CONSTRUCTION DOCUMENTS
MAYBERRY, COLORADO - FILING NO. 4
 BEING A REPLAT OF TRACT A, MAYBERRY, COLORADO SPRINGS FILING NO. 3
 LYING THE NORTHEAST QUARTER OF SECTION 14, TOWNSHIP 14 SOUTH, RANGE 63 WEST OF THE 6TH PRINCIPAL MERIDIAN
 COUNTY OF EL PASO (UNINCORPORATED), STATE OF COLORADO

PCD FILE NO. SF2317

MAYBERRY - FILING NO. 4

CONSTRUCTION DOCUMENTS

LOT 3 STUB PROFILE VIEW
HORIZONTAL SCALE: 1"=20'
VERTICAL SCALE: 1"=4'

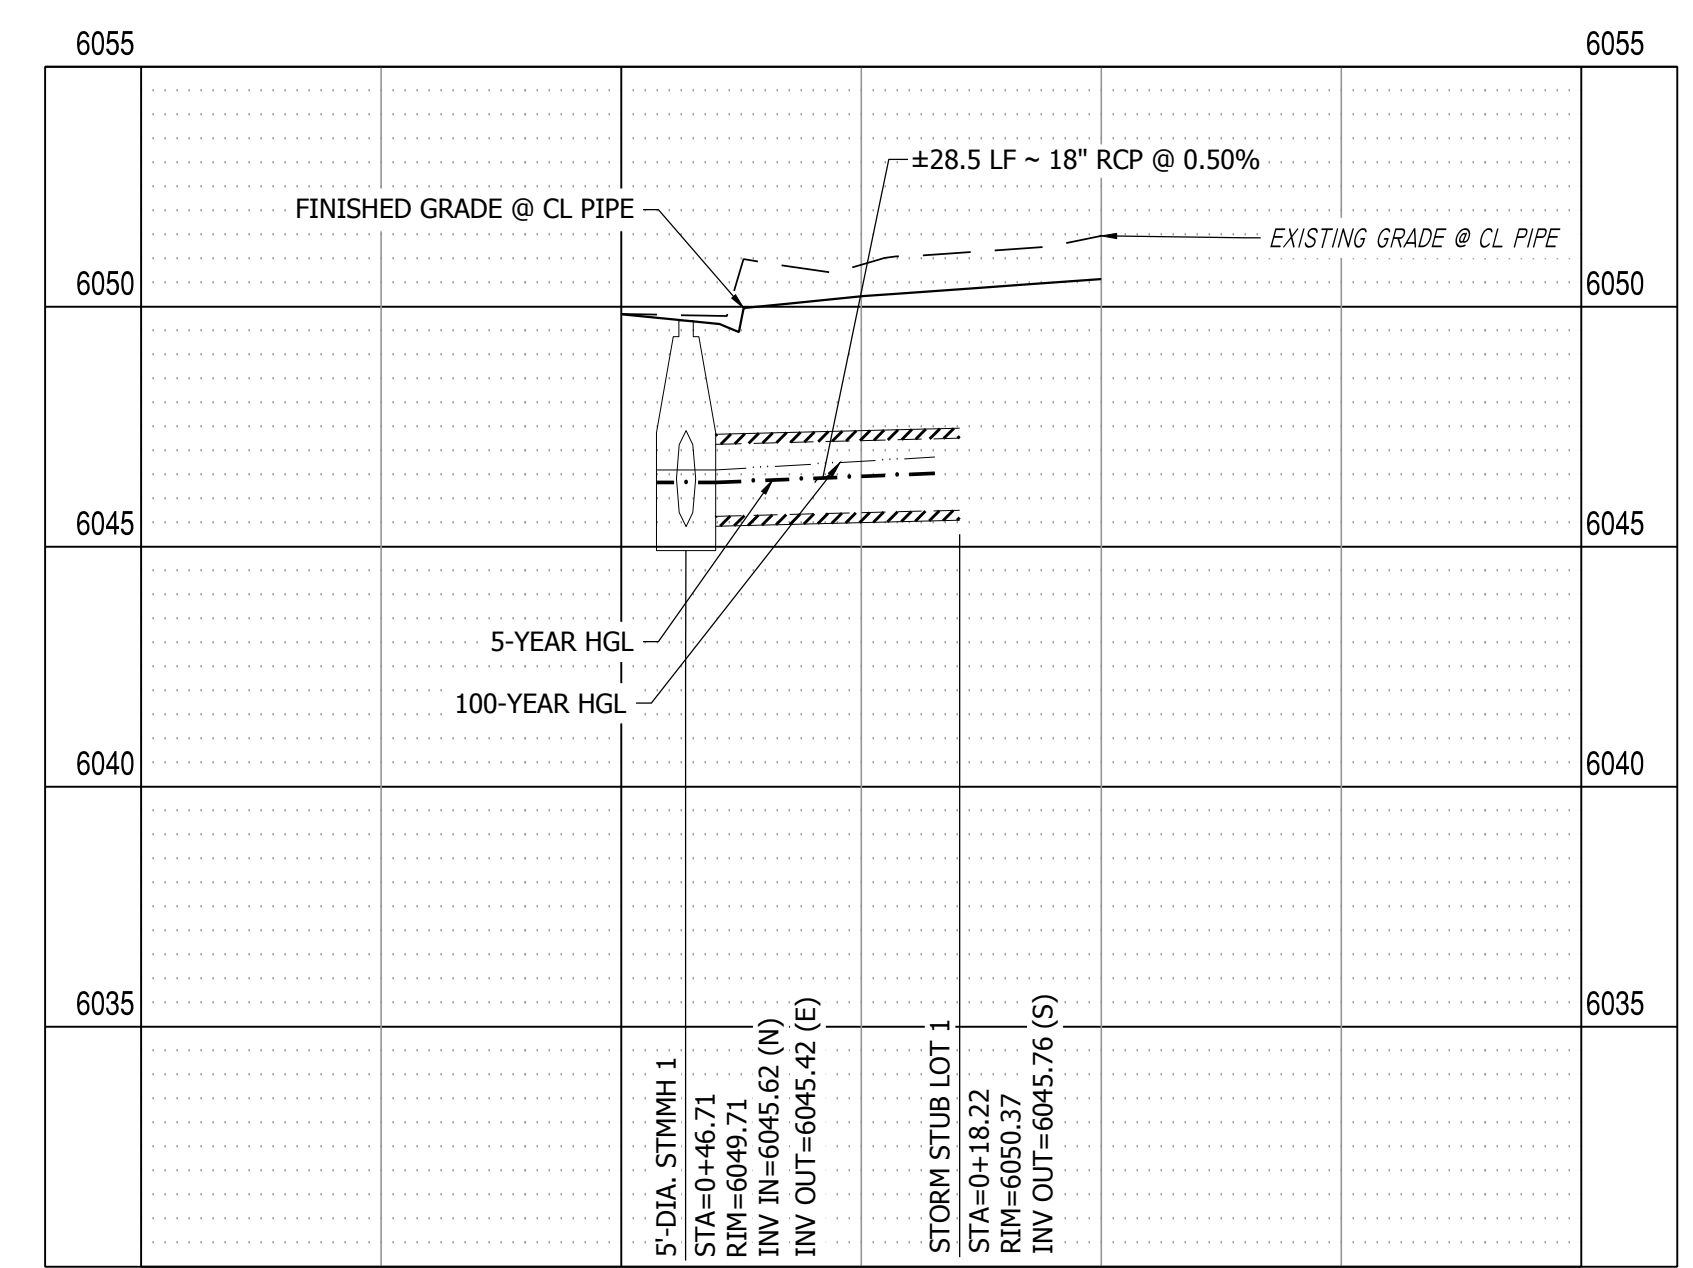
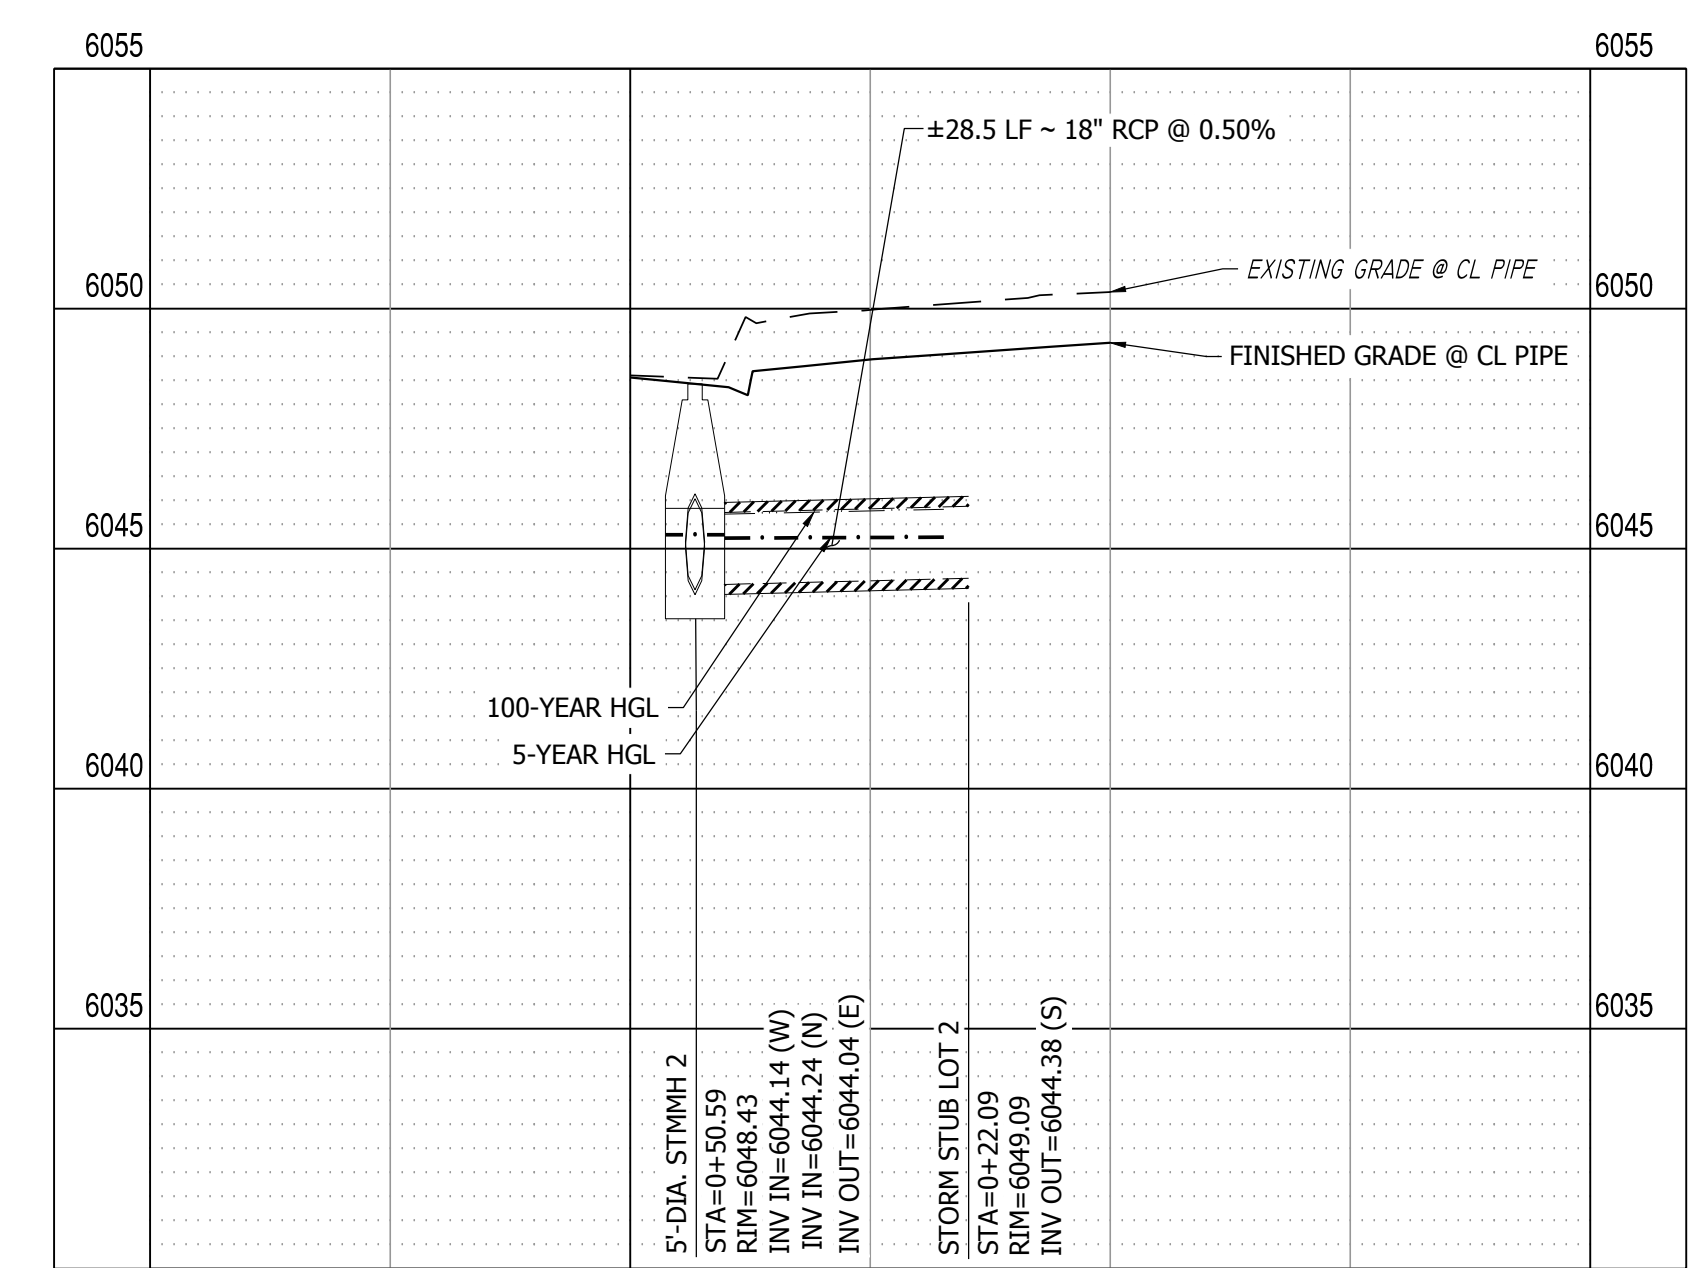
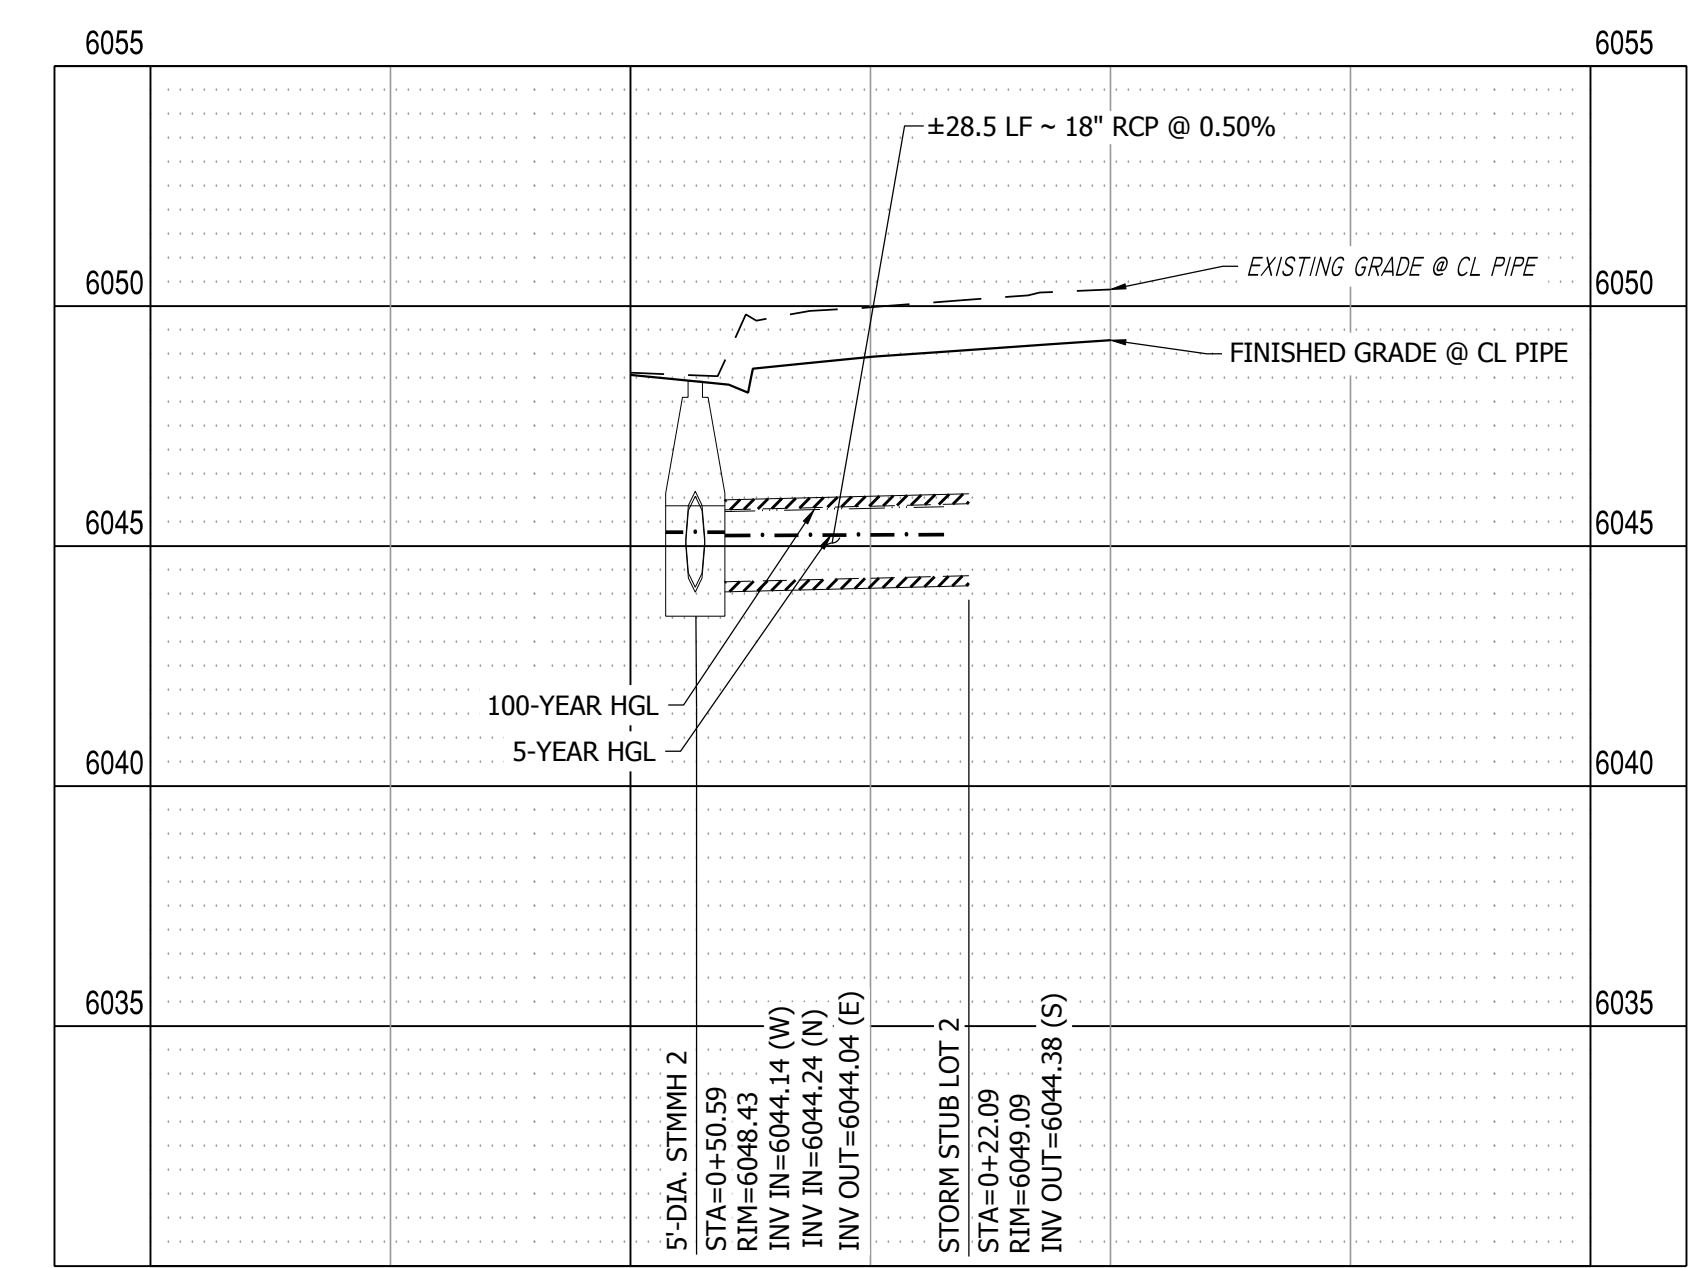
Provide lot 3 profile as this appears to be a repeat of lot 2 profile

Provide lot 3 profile as this appears to be a repeat of lot 2 profile

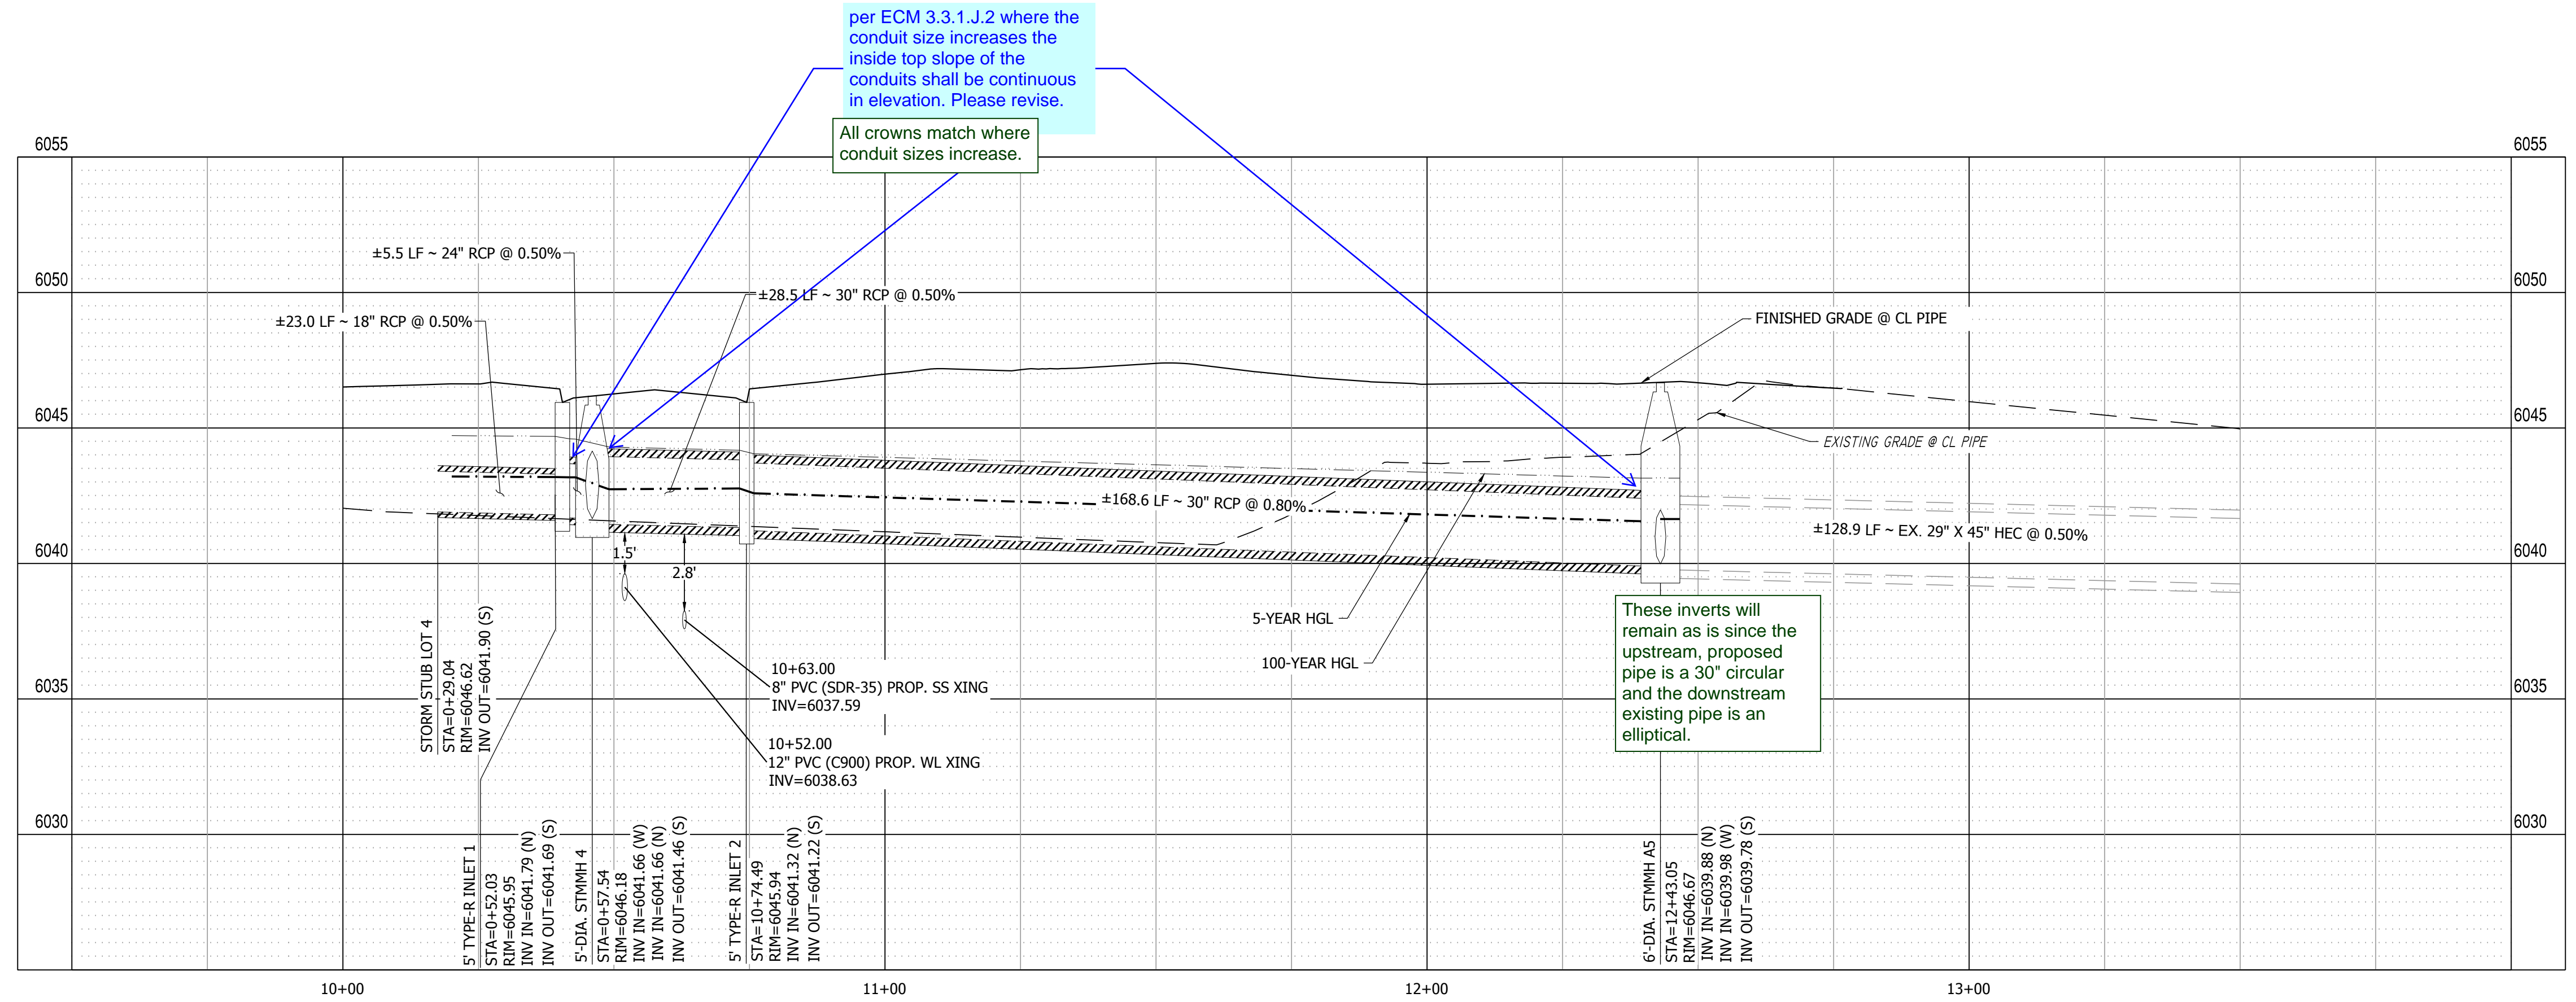
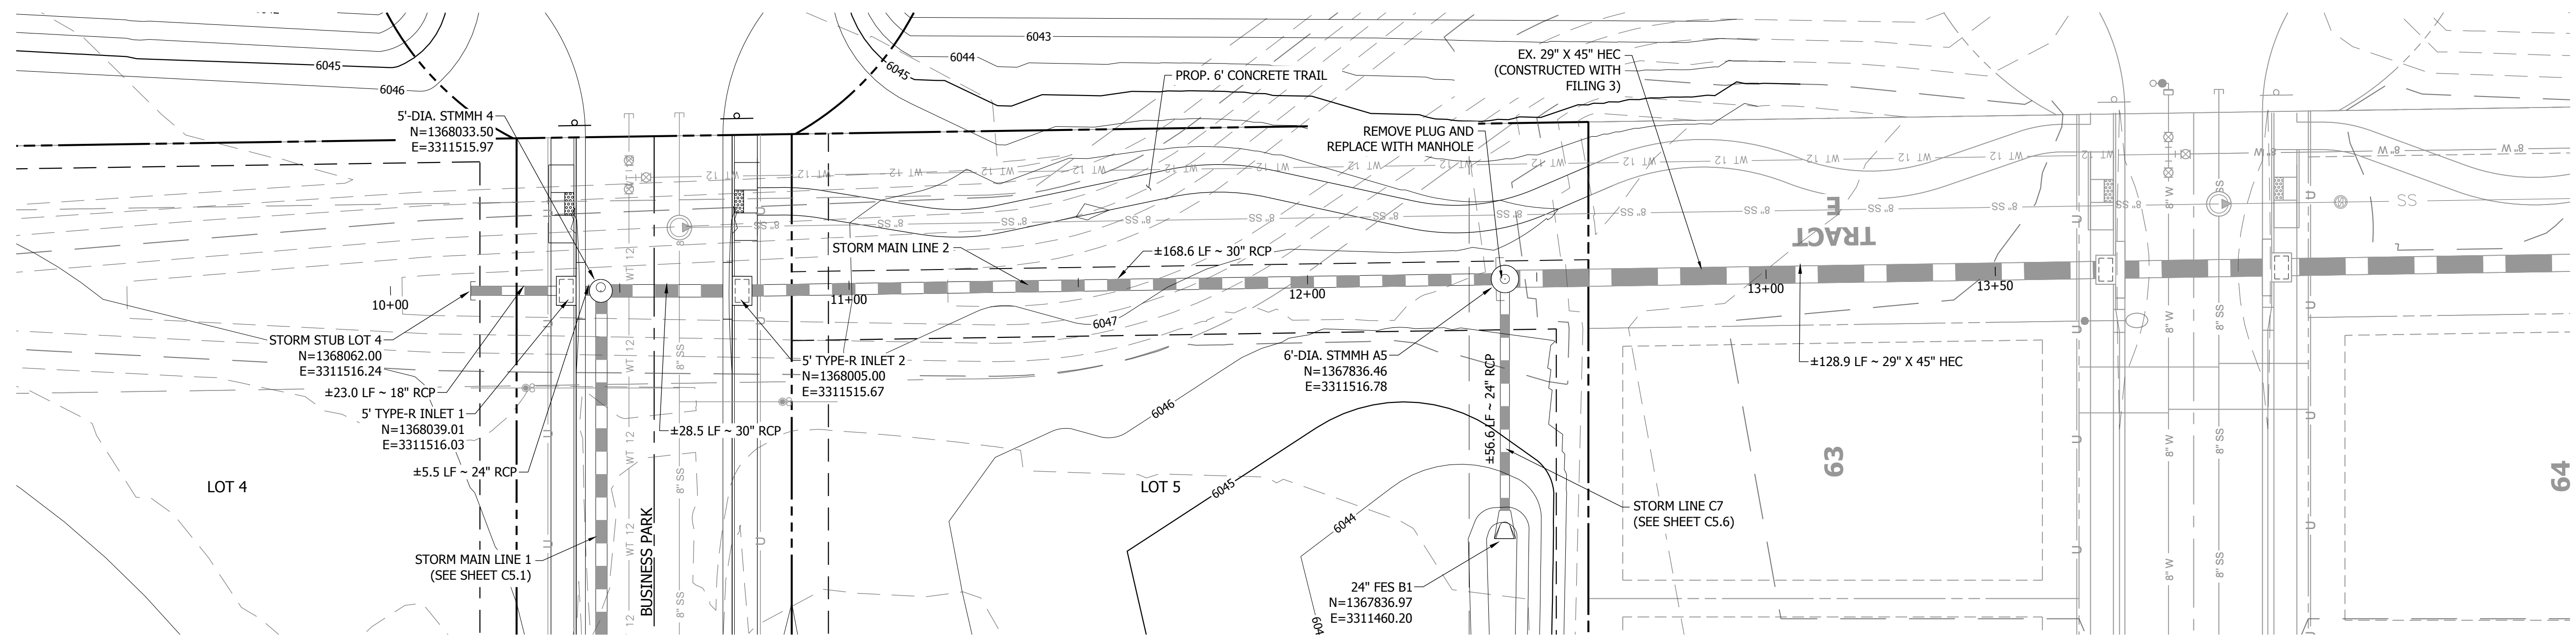
per ECM 3.3.1.J.2 where the conduit size increases the inside top slope of the conduits shall be continuous in elevation. Please revise.
